**Re: Contract T.4650 – Minoru Arena Refrigeration Upgrade – Addendum Three**

MINORU ARENAS  
REFRIGERATION UPGRADE

ADDENDUM # R-3

drawn	PDM	checked	ECB
date	FEB 9/12	scale	NTS
issued		project	1160
drawing number	1160-R1	revision	3

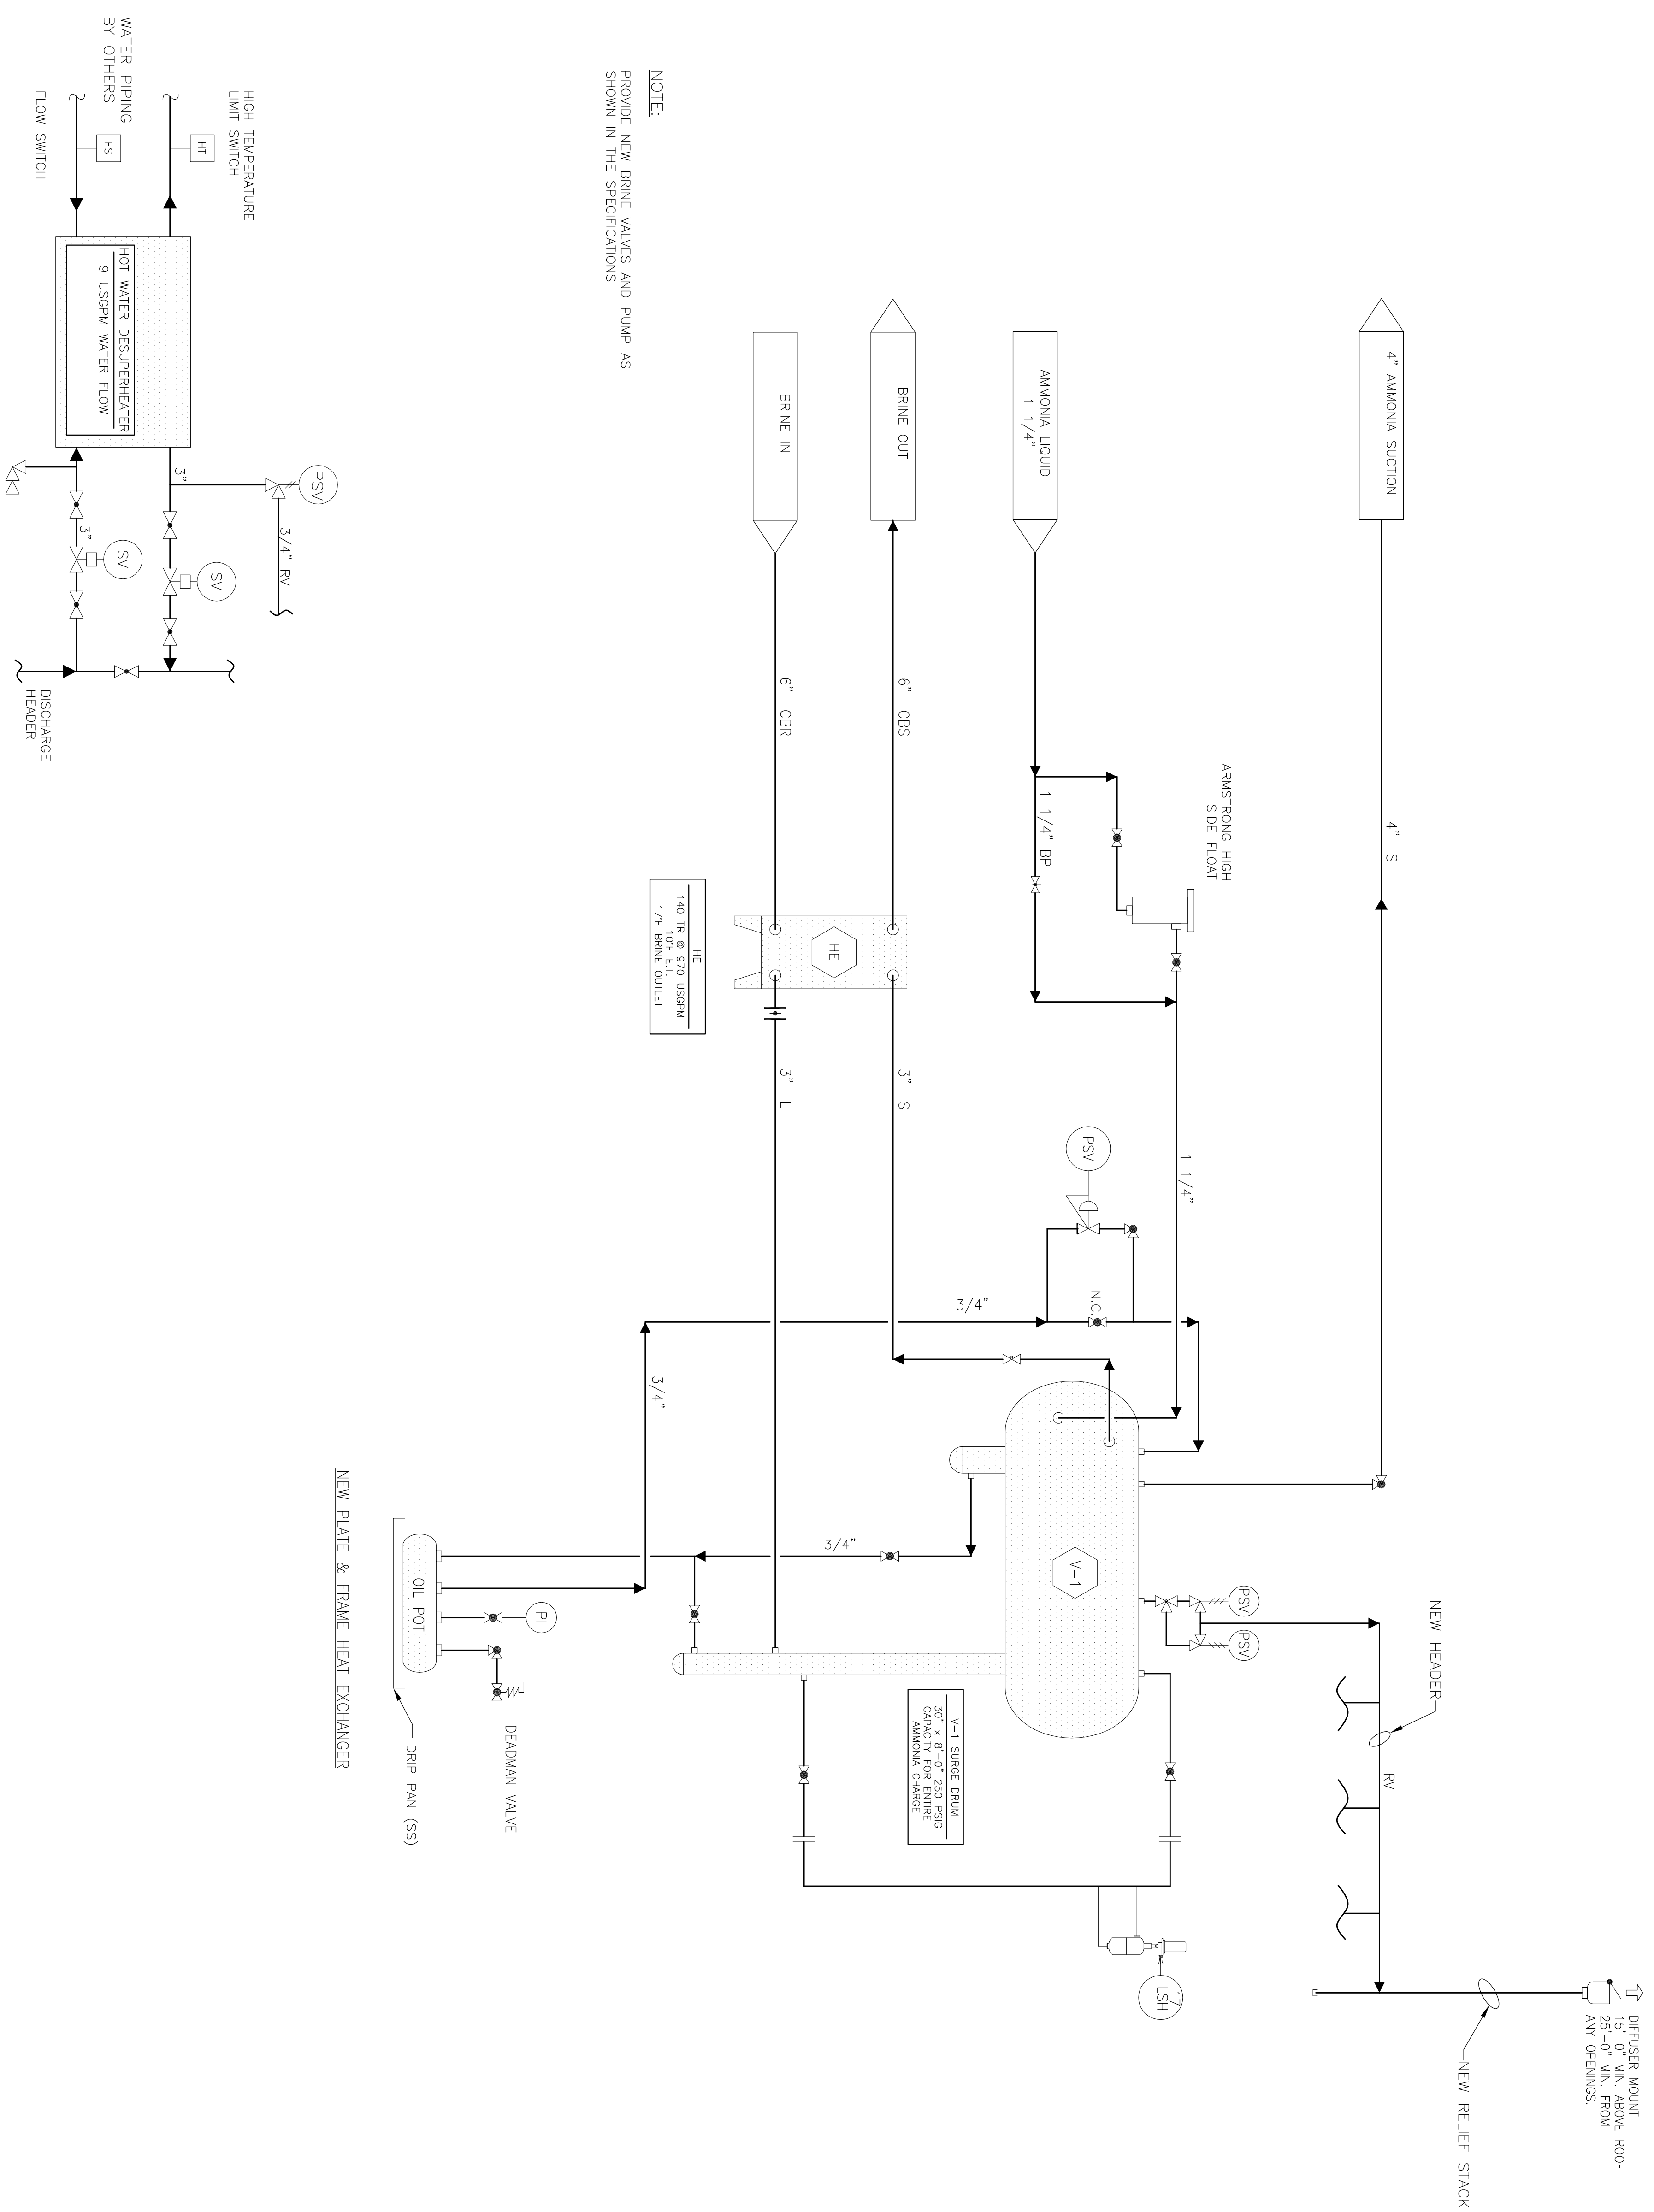
18. Drawing 1160 R-1, Rev. 3 (appended) is issued showing the desuperheater piping and controls. The contractor (refrigeration) is to install and wire the flow switch and high limit thermostats in the water lines in wells supplied by others as part of the desuperheater installation.
